DART AEROSPACE LTD		Work Order: 77308
Description: Crosstube Assembly (412 High Aft)		Part Number: D412-664-243
Inspection Dwg: D412-664-243 Rev: E		Page 1 of 1

DRAWING NO. D412-664-243	TITLE CROSSTUBE ASSEMBLY (412 HI AFT)	REV. E	DART AEROSPACE LTD ENGINEERING ORDER		D.E.O. NO. D412-664-243-E-1	SHEET NO. SHEET 1 OF 2	SCALE NTS
DRAWN	CHECKED	MFG. APPR.	APPROVED		DE APPR.		
DATE 11.03.31	DATE 11/03/31	DATE 11.03.31	DATE 11/03/31		DATE 11.03.31

REMOVED ABRASION STRIP IN FAVOR OF A THIN LAYER OF PROSEAL 890.

DRAWING NO. D412-664-243	TITLE CROSSTUBE ASS'Y (412 HI AFT)	REV. E	DART AEROSPACE LTD ENGINEERING ORDER		D.E.O. NO. D412-664-243-E-2	SHEET NO. SHEET 1 OF 1	SCALE NTS
DRAWN 92	CHECKED ASS	MFG. APPR. E	APPROVED MP		DE APPR. H		
DATE 11.09.07	DATE 11.09.19	DATE 11.09.19	DATE 11.09.19		DATE 11.09.19

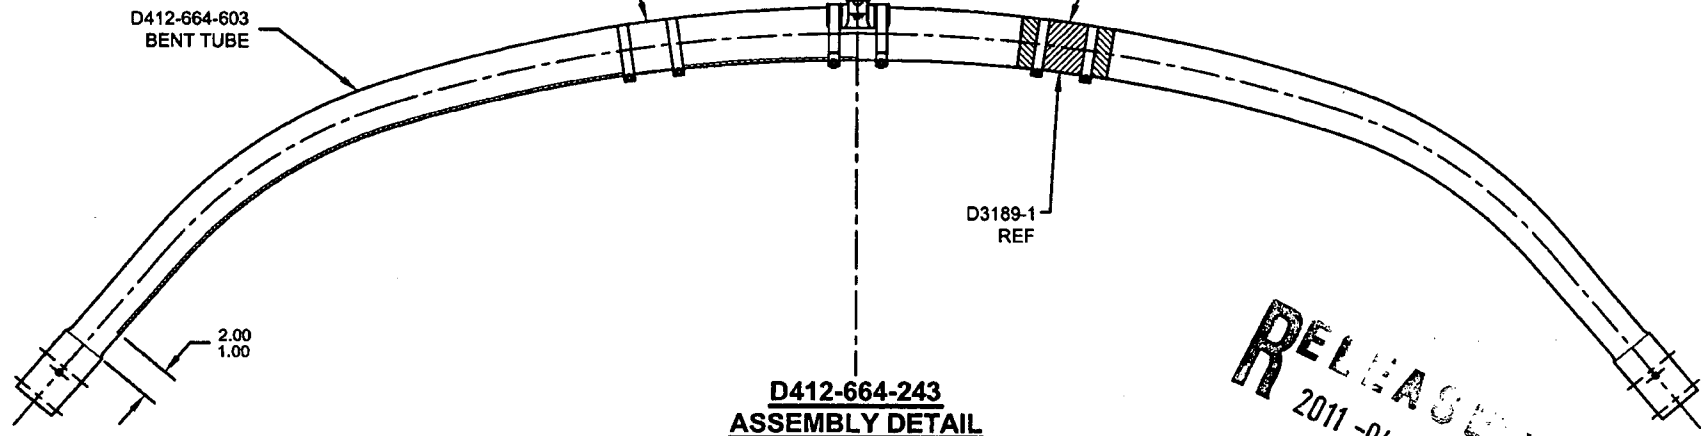
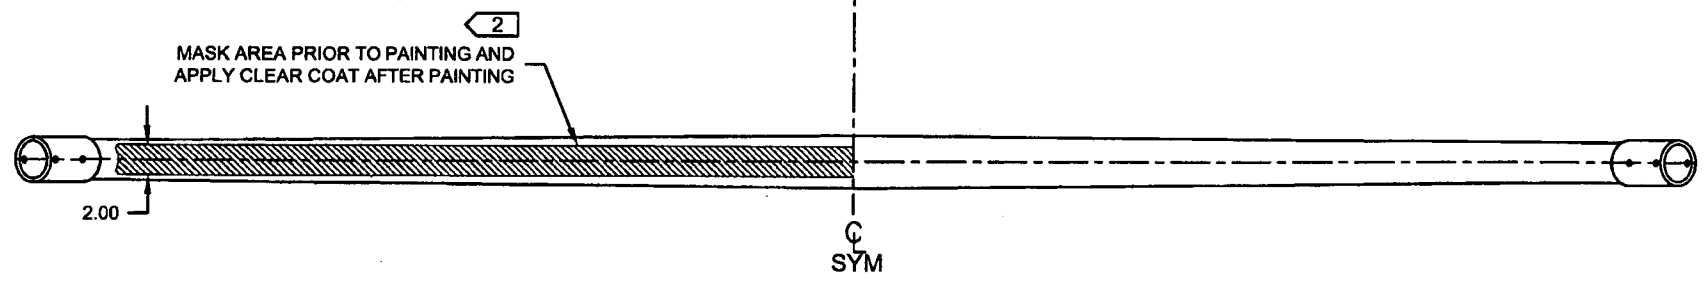
IS:

D3189-1 CHAFING SHIELD (1, INSTALLED OVER PROSEAL 890)
MS21920-28 CLAMP, 2X
2 PL

WAS:

D2856-600-1009 ABRASION STRIP
D3189-1 CHAFING SHIELD (1, INSTALLED OVER ABRASION STRIP)
MS21920-28 CLAMP, 2X
2 PL
